Office Action Summary	Application No. 10/825,836	Applicant(s) HORTON, WADE C.	
	Examiner Adriana Figueroa	Art Unit 3633

DETAILED ACTION

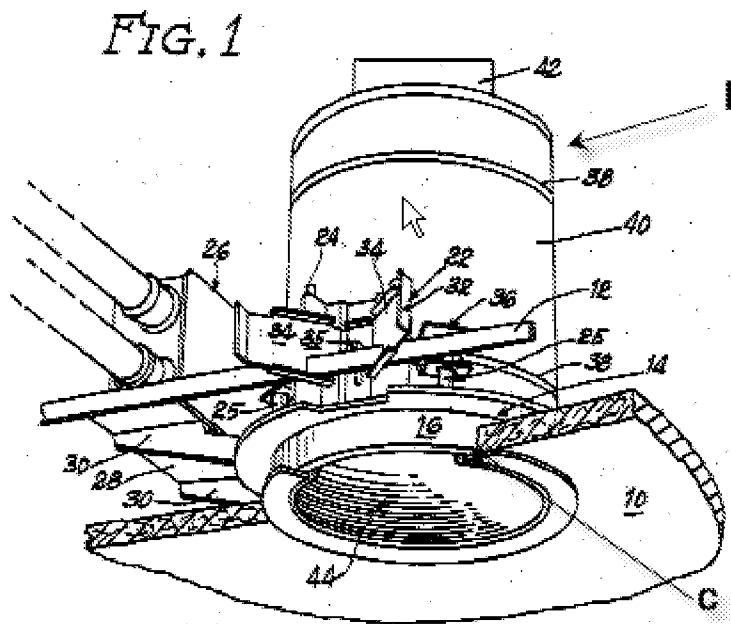
Regarding claim 1, as best understood, Bobrick discloses in combination with a ceiling (10) comprising a planar surface defined by opposing sides and having a circular cutout (c) there through, a recessed lighting fixture (l) mounted on one side of said planar surface over said cutout and conforming thereto, (annotated Fig 1), and a finishing ring (46) defined by an aperture conforming to said cutout, said finishing ring being mounted on another side of said planar surface around said cutout and attached to the recessed lighting fixture (l) for providing a transition from said planar surface to said recessed lighting fixture, (Fig 1, Fig 5), but does not disclose an accent frame comprising a rigid thin sheet of material said rigid thin sheet having an outer edge defining a flat two-dimensional object-shape larger in diameter than a finishing ring, and a convex inner edge defining an circular aperture conforming to said cutout, and having an annular lip circumscribing said aperture and protruding rearwardly there from for insertion into, seating within, and proper positioning with said cutout, said accent frame being sandwiched between said finishing ring and planar surface and maintained in

place there between by the pressure of said finishing ring being retained to said recessed lighting fixture; the flat two-dimensional object-shaped outer edge of said accent frame protruding beyond said finishing ring and serves as an aesthetically pleasing backdrop to said finishing ring, serving to cover up any imperfections in the finish or cut of the surrounding planar surface.

FIG. 2.

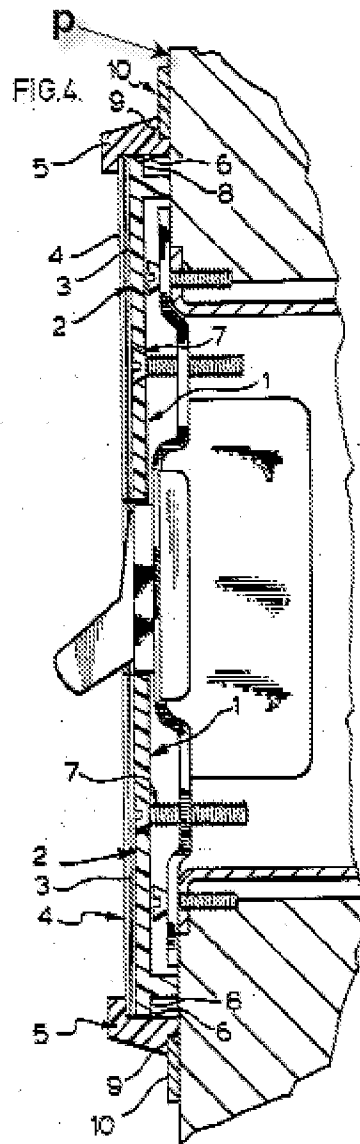
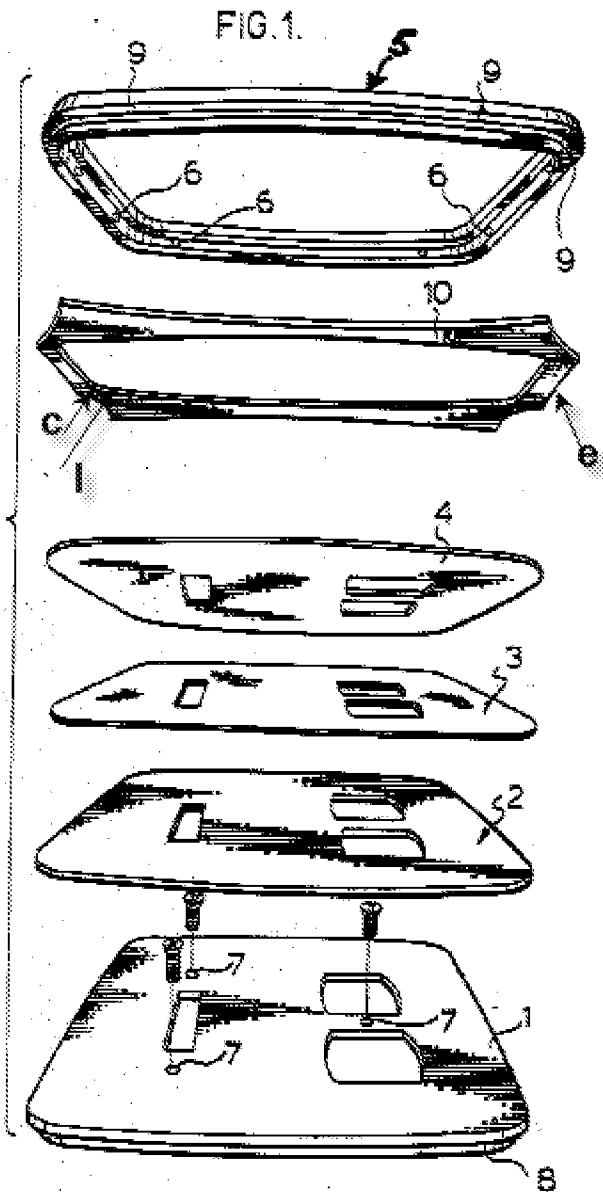
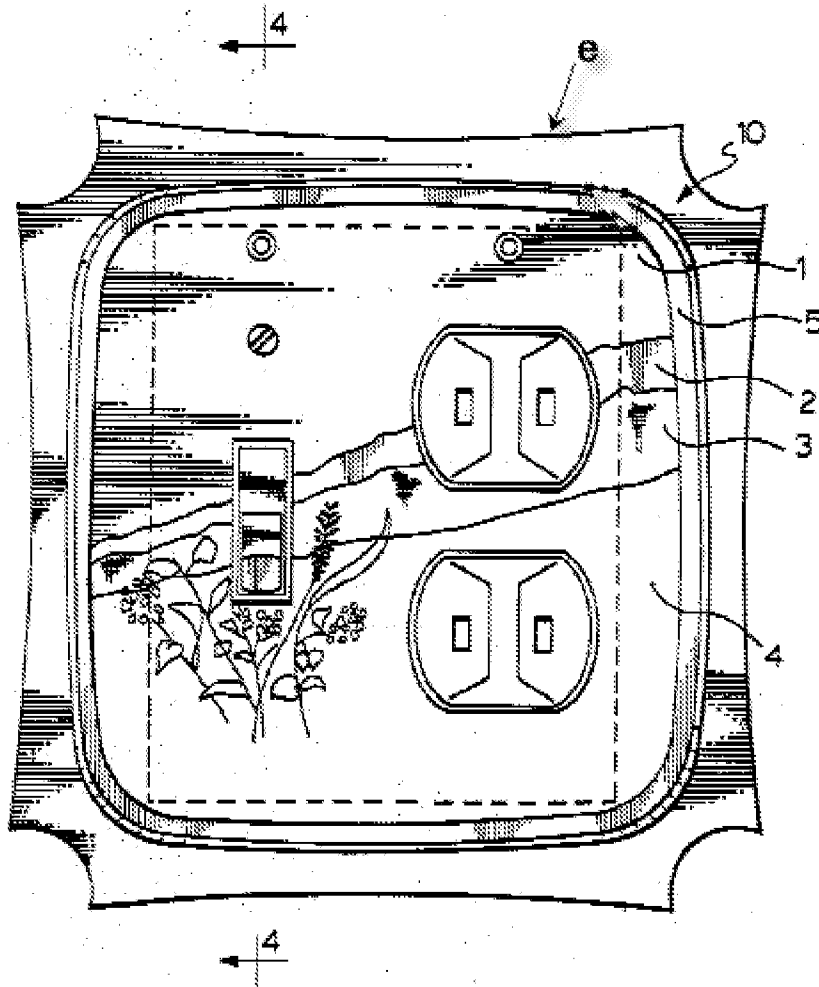
Regarding claim 2, Bobrick modified by Hill discloses as discussed above. Hill further teaches the accent frame (10) having a decorative outer edge (e), (annotated Fig 1, 2).

Regarding claim 3, Bobrick modified by Hill discloses as discussed above. Hill further teaches the accent frame (10) being seated flush with said planar surface (p), (annotated Fig 4).

Regarding claim 4, Bobrick modified by Hill discloses as discussed above. Hill further teaches the accent frame (10) flares slightly away from the planar surface (p) to provide an aesthetically pleasing depth or texture to the frame, (annotated Fig 4).
